Technical Service Information

NISSAN RL4F02A EARLY/HARSH UPSHIFTS

Figure 1

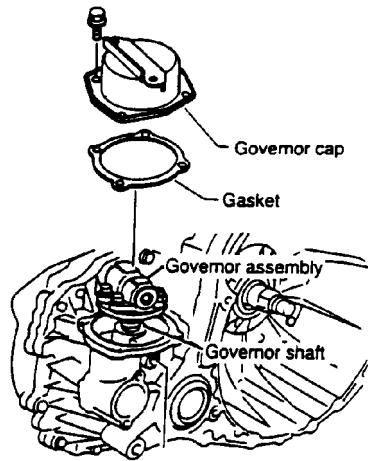
1. Remove battery and bracket.
2. Remove air cleaner, air flow meter, air camper and solenoid valves as an assembly.
3. Remove Governor cap and gasket.
4. Install the new governor assembly (31860-24X04) on the governor shaft, and torque bolts (4) to 3.6-5.1 ft. lb. (See Figure 1).
5. Re-install governor cap and gasket.
6. Disconnect the control cable and throttle cable, remove the throttle lever (Figure 2) and remove the transaxle cover.
7. Disconnect the harness connector from the valve body, and remove ONLY the valve body bolts indicated in Figure 3.
8. Remove and replace the 6 springs that are numbered, as shown in Figure 3.
9. Re-install valve body and torque bolts to 5.1-6.5 ft. lb.
